HISTORIC AND DESIGN REVIEW COMMISSION

HDRC CASE NO: 2019-530
ADDRESS: 105 HERMINE BLVD
LEGAL DESCRIPTION: NCB 9006 BLK 14 LOT 42 43 & E 12.5 FT OF 44
ZONING: R-4,H
CITY COUNCIL DIST.: 1
DISTRICT: Olmos Park Terrace Historic District
APPLICANT: Norma Rogers
OWNER: Norma Rogers
TYPE OF WORK: Porch modifications, installation of an ADA ramp
APPLICATION RECEIVED: September 03, 2019
60-DAY REVIEW: November 02, 2019
CASE MANAGER: Stephanie Phillips
REQUEST:

The applicant seeks a Certificate of Appropriateness to:

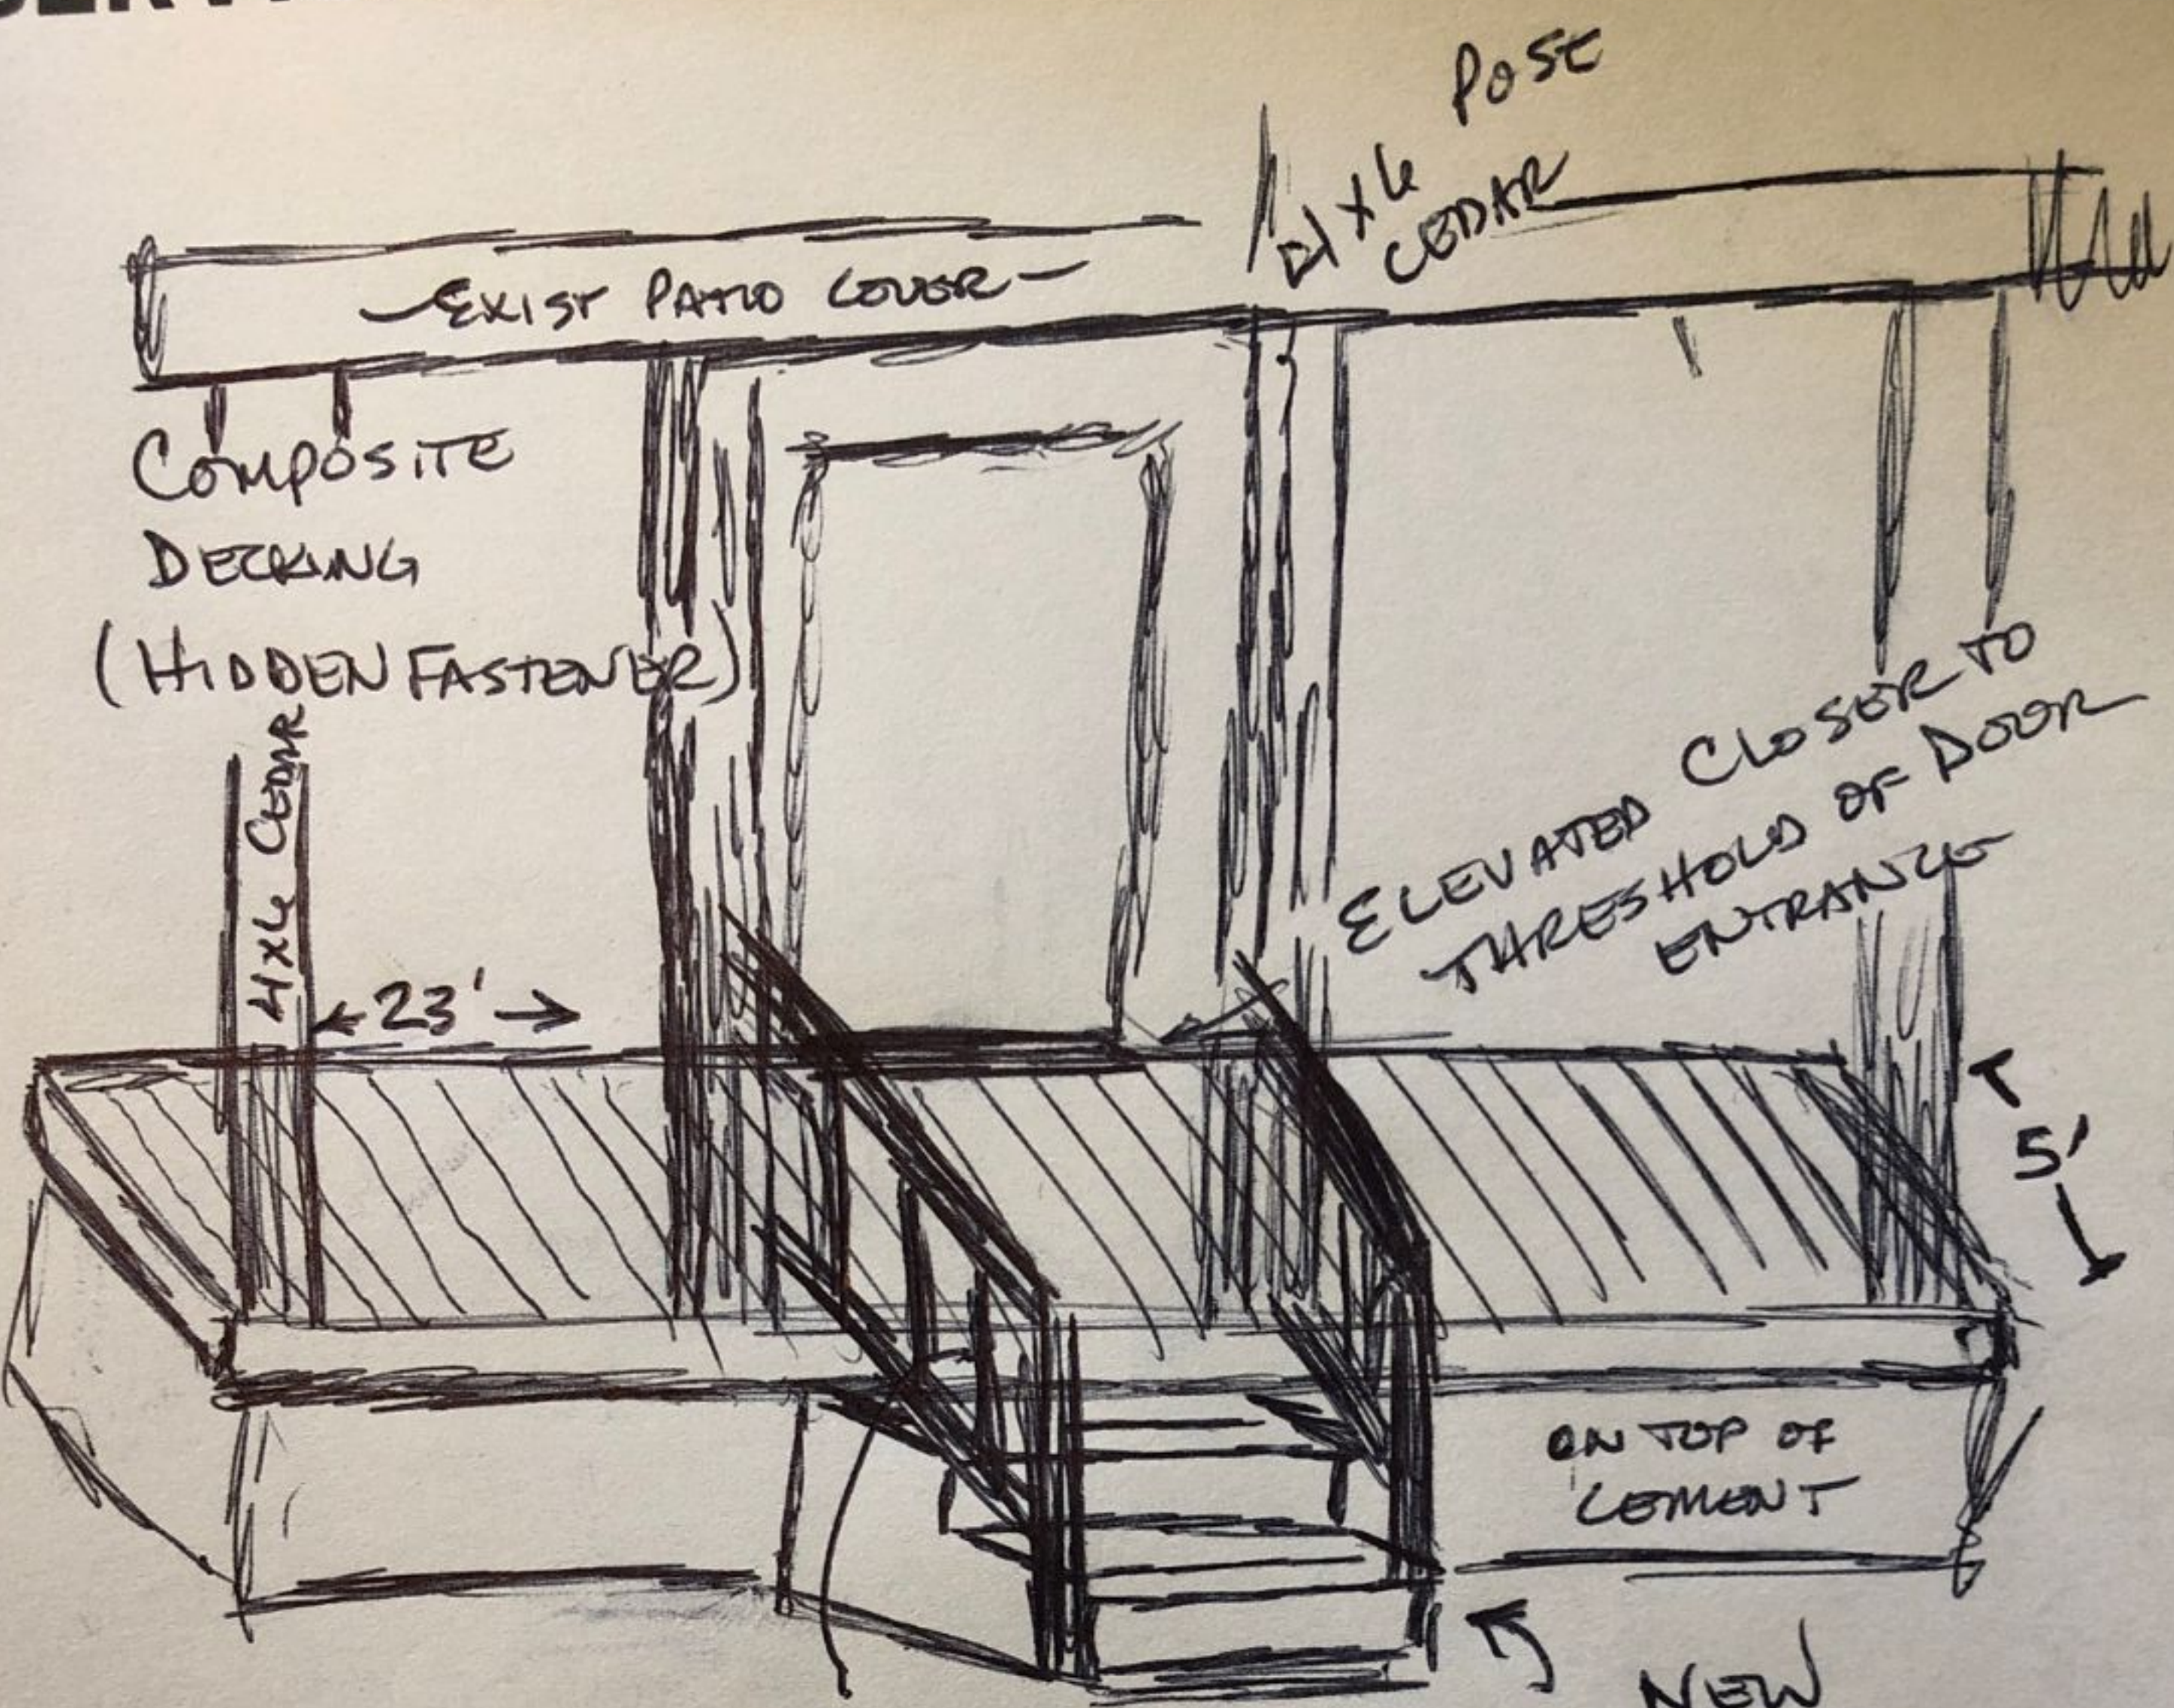
- b. **PORCH DECKING** – The applicant has proposed to install composite porch decking over the existing concrete porch and concrete porch steps. According to the Historic Design Guidelines, existing porch details and materials should be retained. Staff finds that the installation of decking over the existing concrete will create an adverse condition and contribute to the trapping of water between the two materials and facilitate deterioration of the existing concrete porch. This condition may also contribute to water infiltration into the primary structure and other existing materials over time. Staff finds that the existing concrete porch should be repaired in lieu of the installation of composite decking.

- c. **ADA RAMP** – The applicant has proposed to construct an ADA ramp at the front entrance. The ramp will be temporary and removable and will feature cedar railings and posts. According to the Historic Design Guidelines for Site Elements, new ramps should be designed to complement the historic character of the building and be visually unobtrusive to minimize impact, especially if visible from the public right-of-way. Staff finds that the location of the removable ramp does not detract from the significance of the historic structure.

Item 1, Staff does not recommend approval of the composite decking installation over the concrete porch and stairs based on finding b. Staff recommends that existing concrete porch be repaired to address settling issues in lieu of the installation of composite decking to conceal deterioration.

Item 2, Staff recommends approval of the ADA ramp and railing installation based on finding c.
